## Economic and Social Council

### **Proposal for Supplement 1 to the 02 series of amendments to Regulation No. 94 (Frontal collision protection)**

#### **Submitted by the Working Party on Passive Safety\***

Paragraph 6.2.1., amend to read:

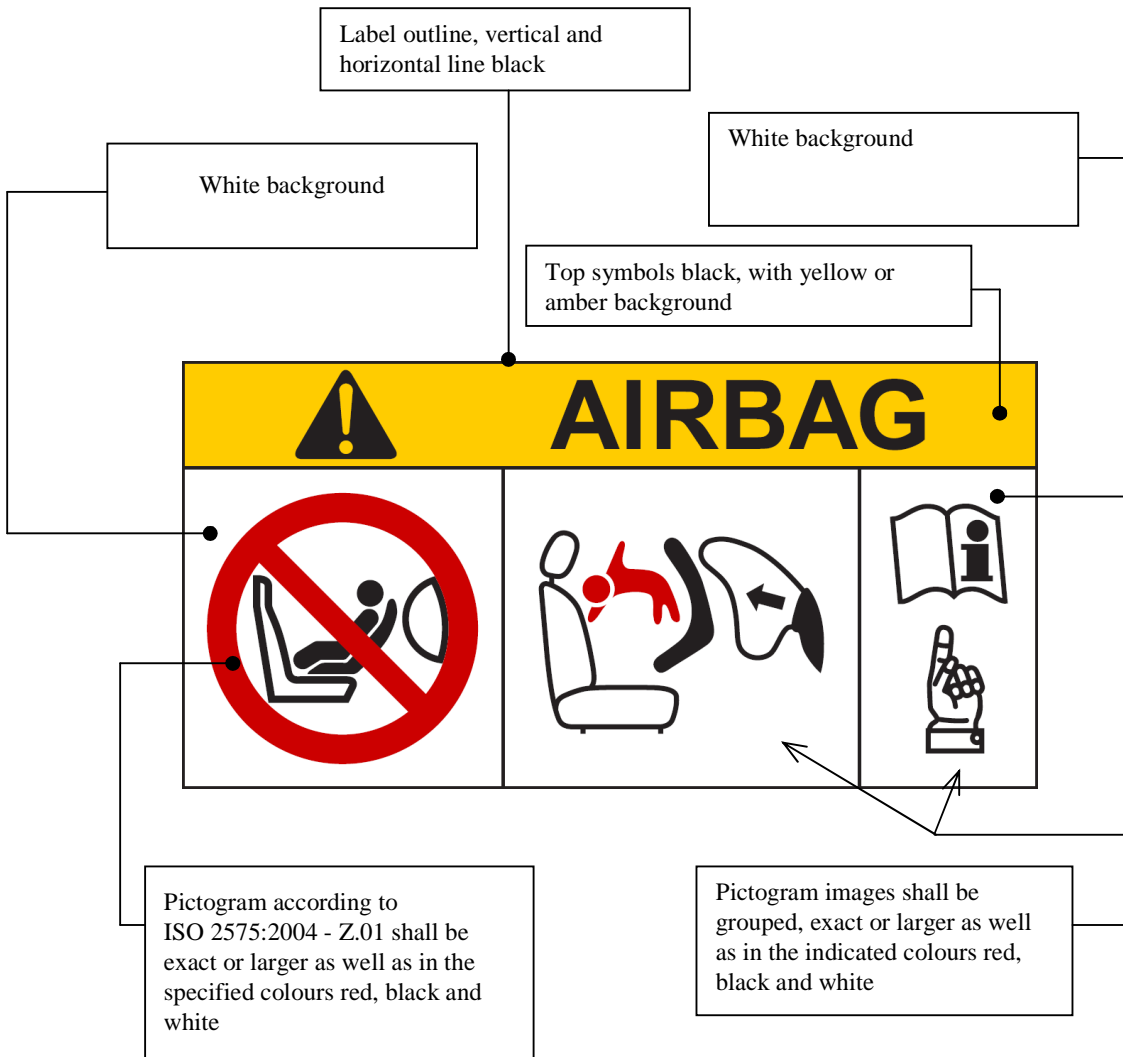
"6.2.1. As a minimum, this information shall consist of a label containing clear warning pictograms as indicated below:

The overall dimensions shall be at least 120 x 60 mm or the equivalent area.

The label shown above may be adapted in such a way that the layout differs from the example above; however, the content shall meet the above prescriptions."
